# UNITED STATES PATENT AND TRADEMARK OFFICE

| APPLICATION NO.  | FILING DATE | FIRST NAMED INVENTOR    | ATTORNEY DOCKET NO. | CONFIRMATION NO. |
|--|-------------|-------------------------|---------------------|------------------|
| 10/535,058   | 05/13/2005  | Herfried Karl Wieczorek | DE 020240           | 9416             |

| <b>Office Action Summary</b> | Application No.<br>10/535,058 | Applicant(s)<br>WIECZOREK, HERFRIED KARL |  |

## DETAILED ACTION

Figure 3 – X-ray Apparatus – U.S. patent Application Publication 2001/0005409 to Gohno et al.

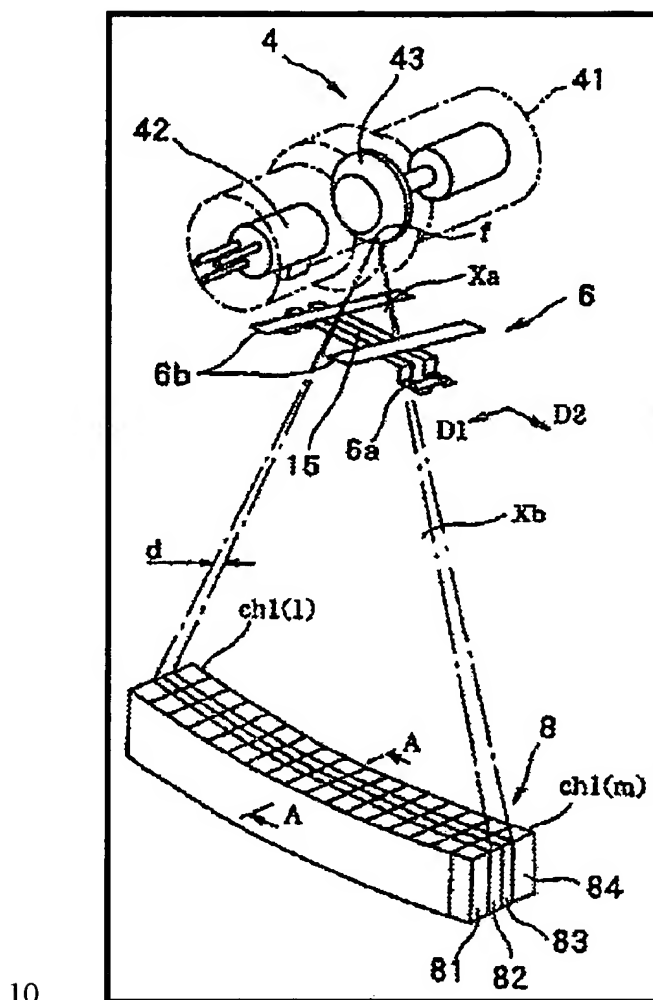
9. Claims 1, 2, 3 and 6 are rejected under 35 U.S.C. 102(b) as being anticipated by Gohno et al. (U.S. patent Application Publication 2001/0005409).

11. As per claim 1, Gohno et al. disclose an X-ray apparatus comprising an X-ray source (4) and detector (8); the detector including a photoconductor (not shown above - treated as a photosensitive element such as a photodiode), readout elements and an output circuit (see Figs. 2 & 5-7, not shown above), wherein a central group of readout elements is located in a central region (see Fig. 3 above) and a peripheral group of readout elements located in a peripheral region which surrounds the central region; the X-ray apparatus being provided with a selection

system (6) to select the central group of readout elements so as to supply pixel signals from the central group of readout elements to the output circuit.

12. **As per claim 2**, Gohn et al. disclose an X-ray apparatus wherein the selection system includes an X-ray shielding member that shields the peripheral region of the photoconductor from incident X-ray radiation (see Fig. 3 above).

13. **As per claim 3**, Gohn et al. disclose an X-ray apparatus comprising a collimator between the X-ray source (4) and x-ray detector (8), wherein the collimator comprises an X-ray absorbing member which is spatially registered with the peripheral region of the photoconductor (see Fig. 3 above).

14. **As per claim 6**, Gohn et al. disclose an X-ray apparatus wherein the selection system electrically isolates the peripheral group of readout elements from the output circuit (see Fig. 3 above).

one having ordinary skill in the art at the time the invention was made to modify the apparatus of Gohn et al. such that it incorporated electrodes of readout elements of the peripheral group being smaller sized than collecting electrodes of the readout elements of the central group. One would have been motivated to make such a modification for the purpose of enhancing signal readout of the central detection array while minimizing the influence of the shaded peripheral group as suggested by Gohn et al. (see Fig. 3 above).
